Southampton to London Pipeline Project

Responses to Written Representations -
Local Authorities

Application Document: 8.23

December 2019

Figure 1: Ancient Woodland and Potential Ancient Woodland Plan

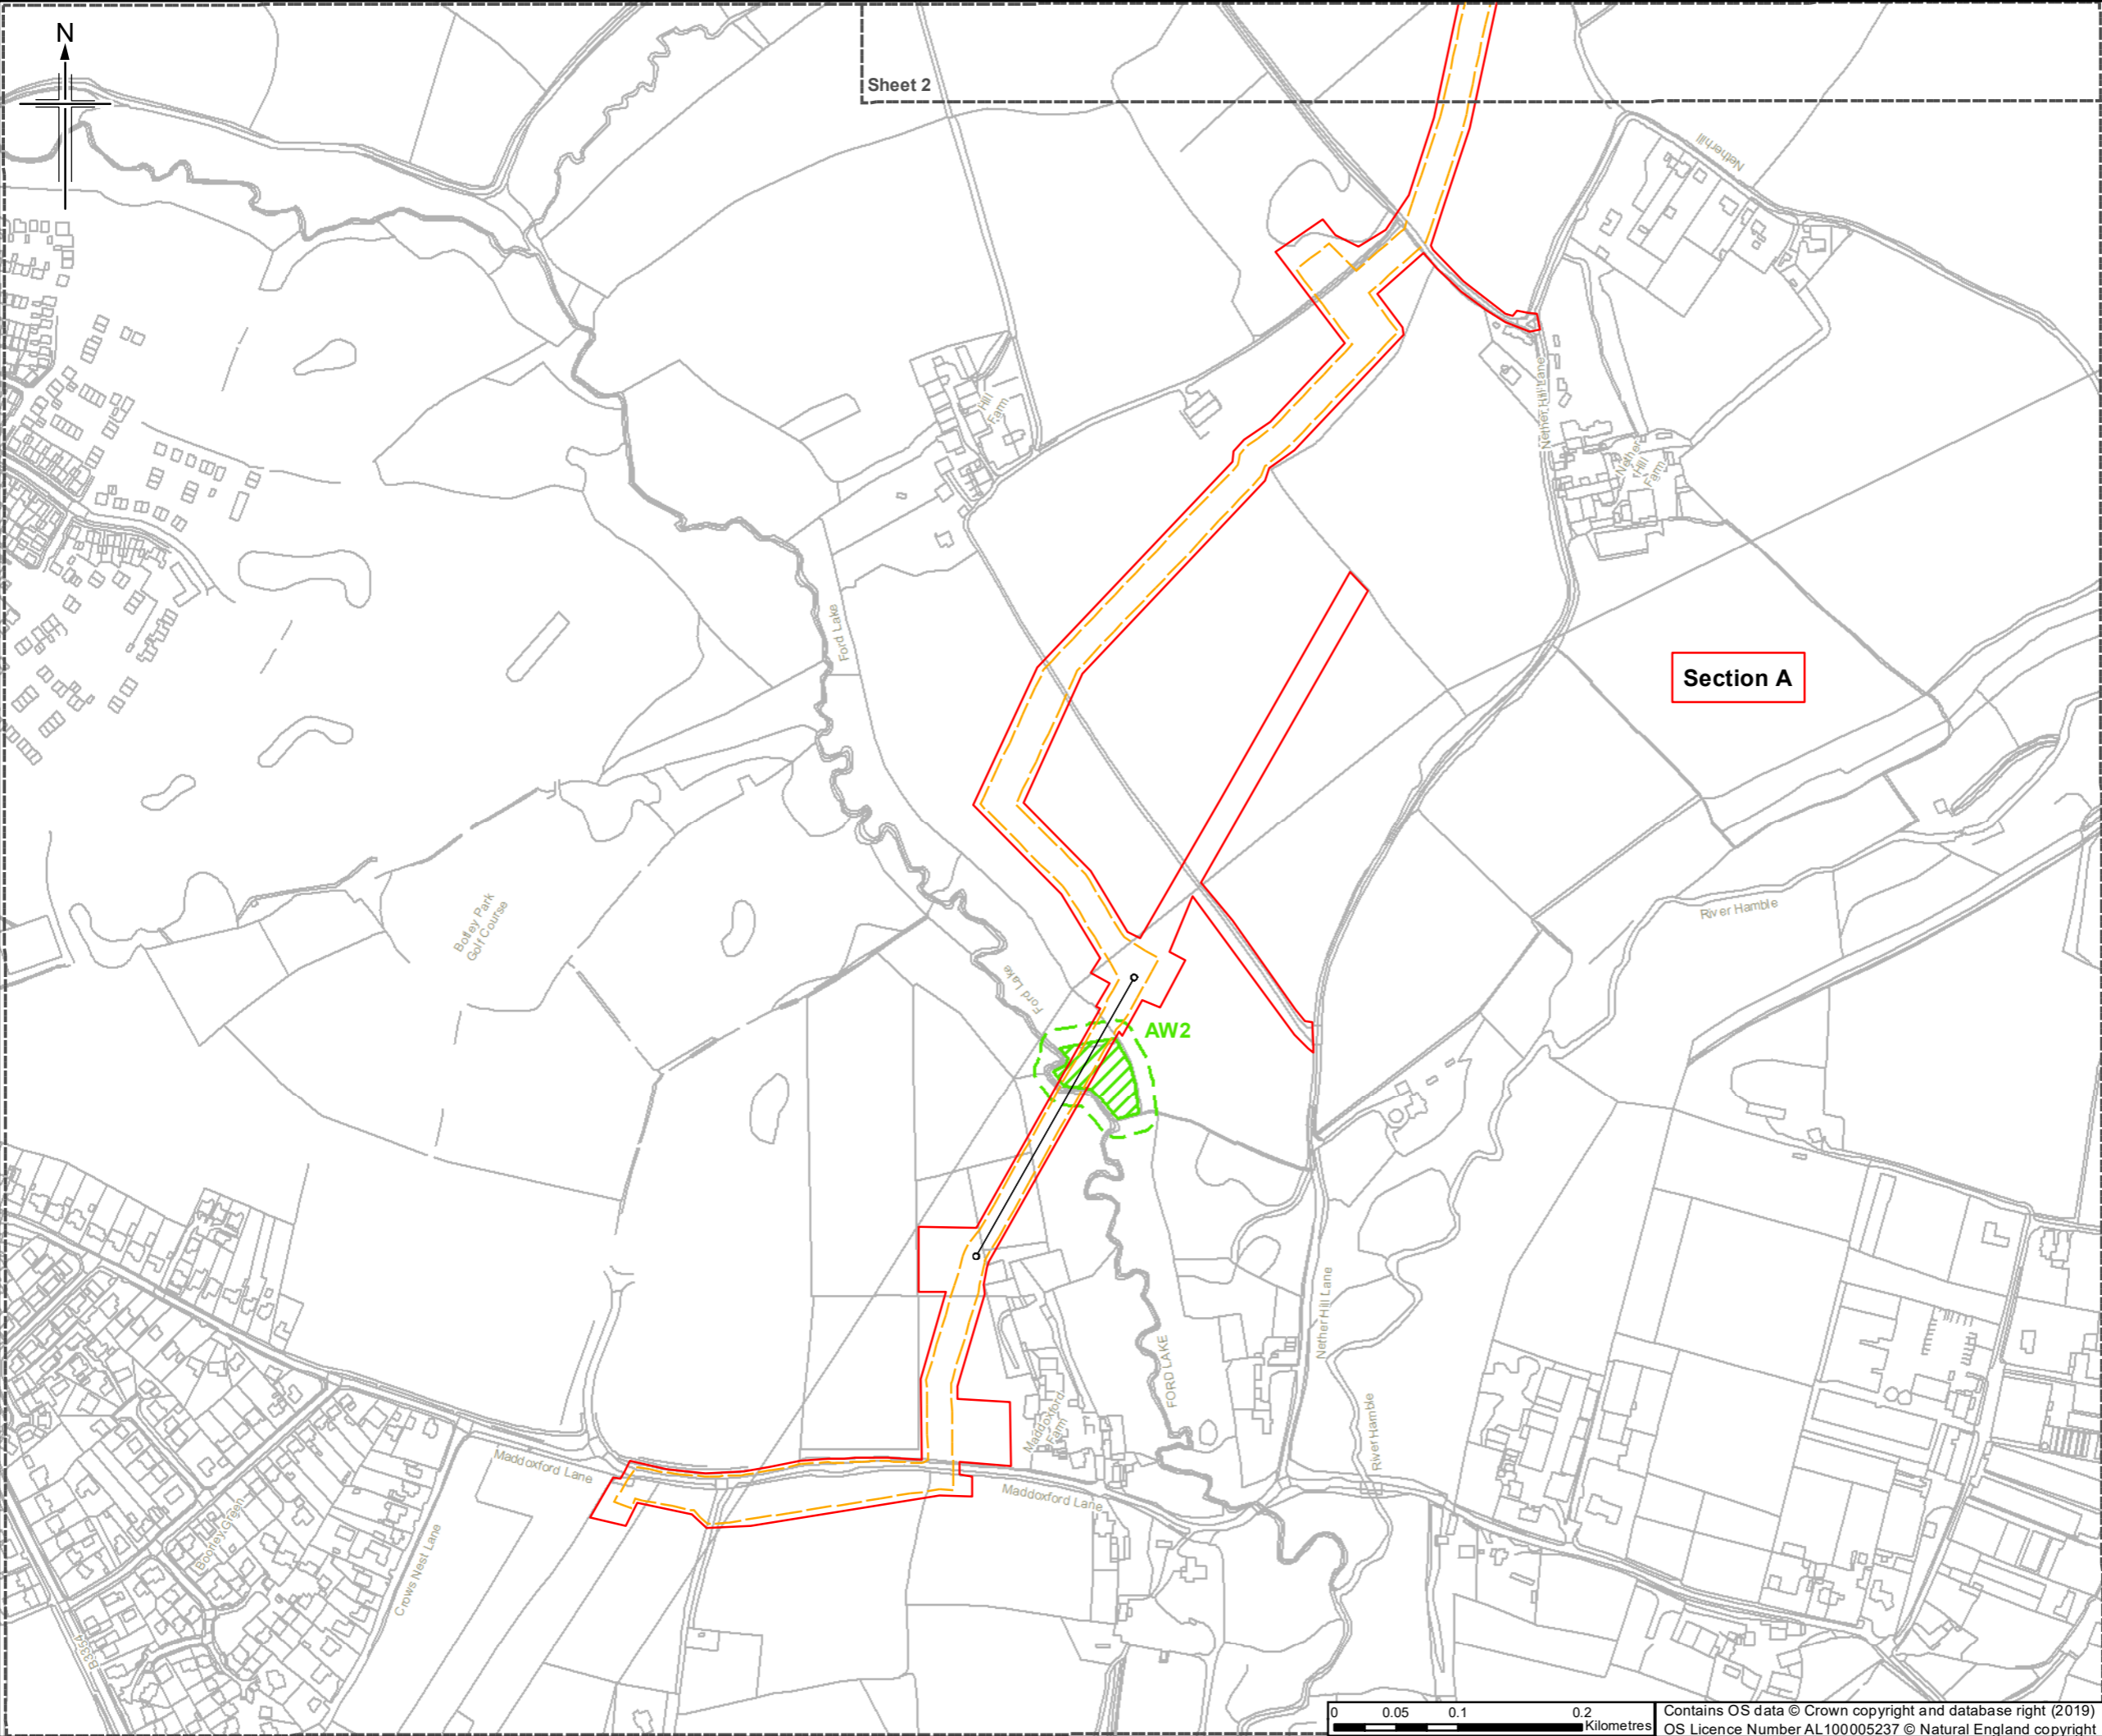
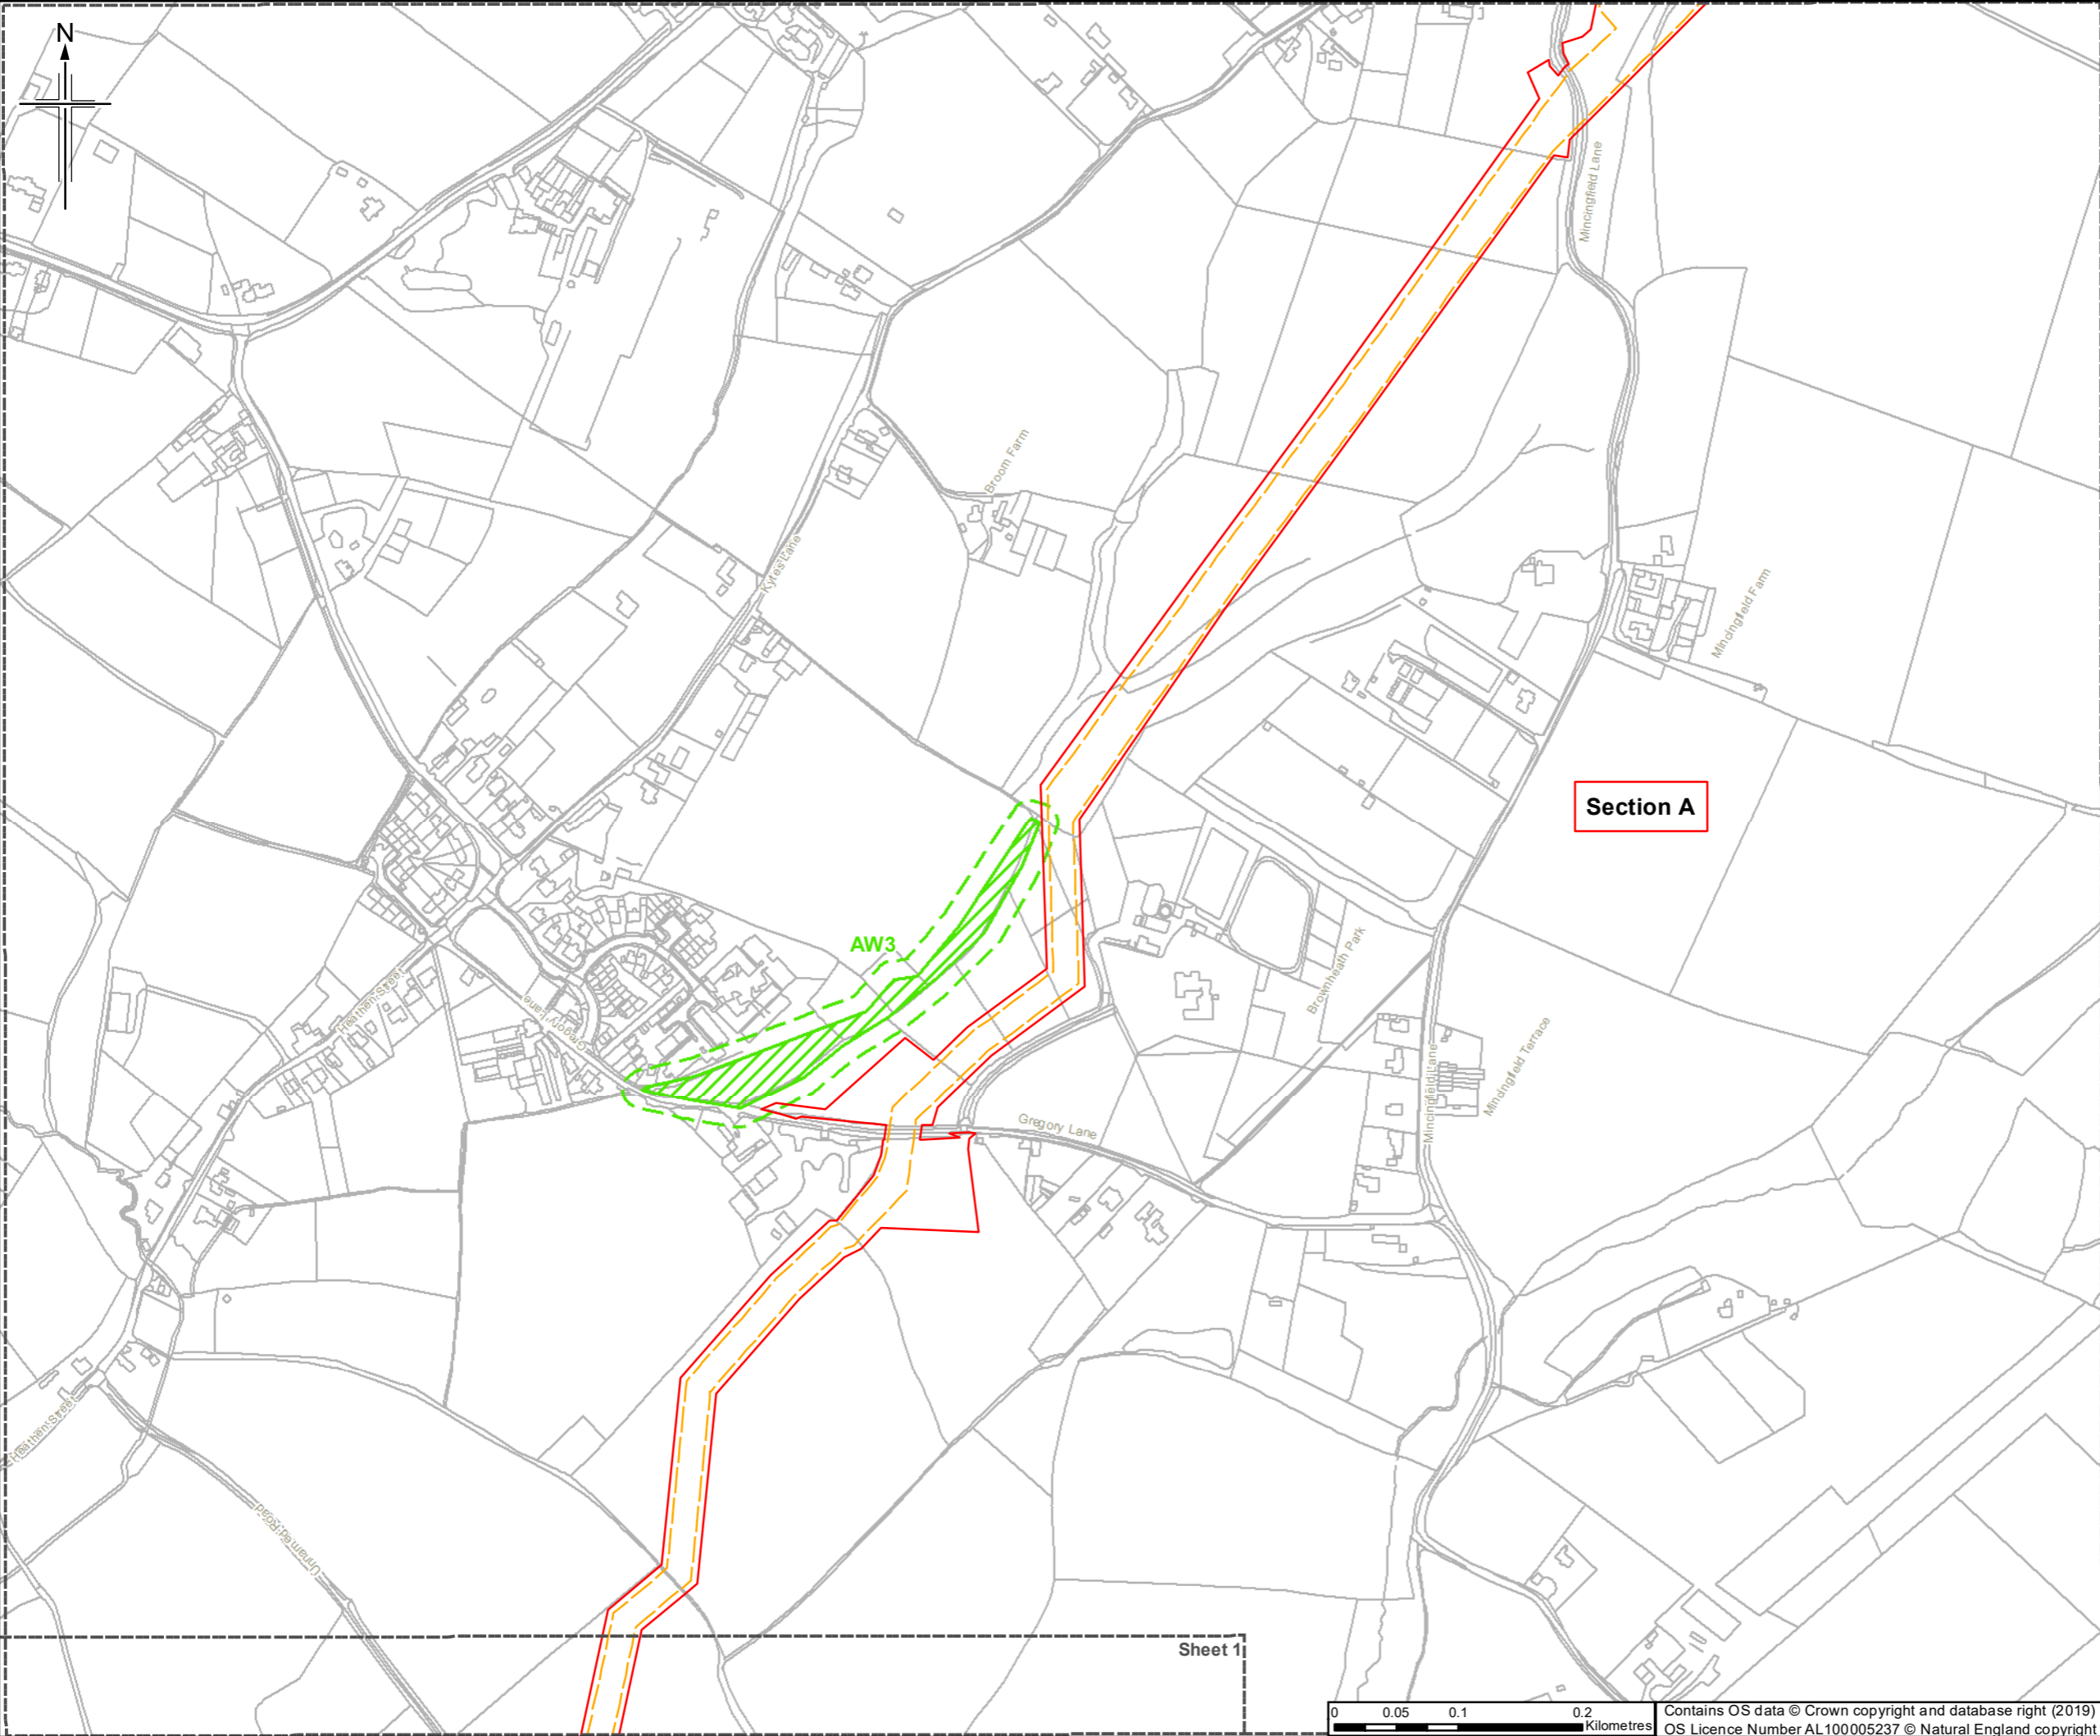
WR Para Ref	Point raised	Applicant response to point raised:
		<ul style="list-style-type: none"> reinstatement hedgerow planting would be relatively quick to establish; reinstatement tree planting would take a little longer to establish, but would have reached approximately 7m in height after 15 years. <p>It is therefore considered that, by year 15, there would be little noticeable change in the landscape character of the National Park when compared to the existing condition, and the effects on the landscape would not be significant.</p>
	<p>In its response to LV.1.25, the SDNPA furthermore requests that the A31/A32 Junction, Northfield Lane (Chawton) logistics hub be added to the list of representative viewpoints set out in the LVIA.</p>	<p>Whilst the Applicant does not consider such a representative viewpoint to be necessary, this has been prepared and is provided at Appendix 1.</p>
<p>Para 3.19 to 3.33</p>	<p>Trees and Woodland</p> <p>The SDNPA sets out concerns regarding potential impacts on, and the applicant's approach to veteran trees and ancient woodland.</p> <p>The SDNPA has requested a plan to identify which of the mitigation hierarchy measures apply to which ancient woodland.</p>	<p>The Applicant has prepared a Technical Note on Ancient Woodland and Veteran Trees (REP2-061) which sets out the approach to reduce the impacts of the project on Ancient Woodland and potential ancient woodland and Veteran Trees and potential veteran trees within 15m of the Order Limits.</p> <p>The Technical Note sets out a hierarchy of mitigation principles, ranging from the use of buffers and ground protection around trees, to the requirement for specialist construction techniques to be used for any unavoidable excavation within root protection areas. The Technical Note has regard to the joint standing advice from the Forestry Commission and Natural England (Ancient woodland, ancient trees and veteran trees: protecting them from development, 2018) when developing the hierarchy of mitigation principles, with avoidance of works within 15m of the edge of ancient woodland and 15m from the stems of veteran trees recommended where practicable.</p>

WR Para Ref	Point raised	Applicant response to point raised:
		<p>Natural England has signed a SoCG with the Applicant (REP1-005), Section 3 of which sets out agreement on matters including:</p> <ul style="list-style-type: none"> • avoiding classified ancient woodland and reducing impacts on potential ancient woodland; • the mitigation proposed in Chapters 7 (Application Document APP-047) and 16 (Application Document APP-056) of the ES; and • working methods in relation to ancient woodland and veteran trees. <p>The Forestry Commission has signed an SoCG with the Applicant (REP2-025), Section 3 of which sets out agreement on matters including:</p> <ul style="list-style-type: none"> • that the proposed approach to mitigating effects on Ancient Woodland, potential ancient woodland and veteran trees, as described in the ES (Application Document APP-056) and the further information included in the Ancient Woodland and Veteran Trees Technical Note (REP2-061) are appropriate; • that appropriate measures have been taken to identify all areas of Ancient Woodland, and areas of Potential Ancient Woodland that do not appear on Natural England's Ancient Woodland Inventory; and • that the Order Limits avoid all areas of existing classified Ancient Woodland. <p>In addition, the Applicant has prepared a plan showing the locations of Ancient Woodland, potential ancient woodland, Veteran Trees and potential veteran trees (see Figure 1 and 2 appended to this document).</p>
